# Access Compliance Report

## Public Rights-of-Way

### (Curb Ramps)

Intersection ID: 11610	Main Street: COLE_DR	Cross Street: GLENVILLE_AV	Location: NE
ADA ID: 9FF531260443	Ramp Type: ParaDiag	Initial Pass/Fail: Fail	Overall Compliance: No
Codes/Mitigation Info/Possible Solution		Field Measurements/Component Compliance	
Severity Score: 13.75

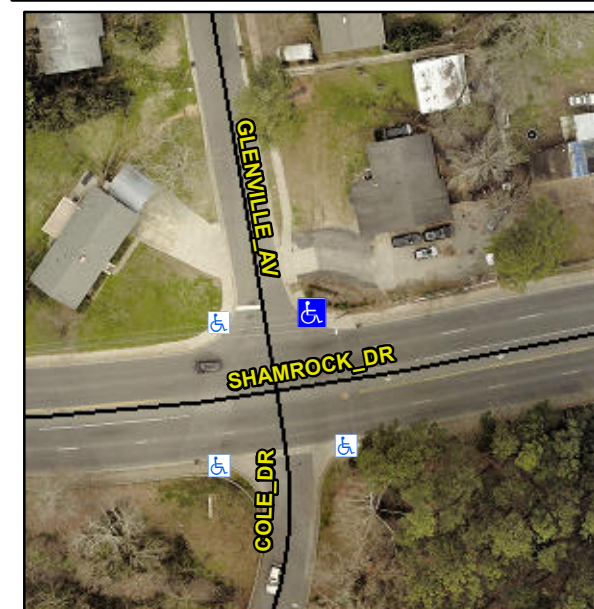
**LT RP < 5%**

**R304.5.3, R304.3.2**

**Remove & Replace Curb Ramp With Two New Directional Ramps or Equivalent.**
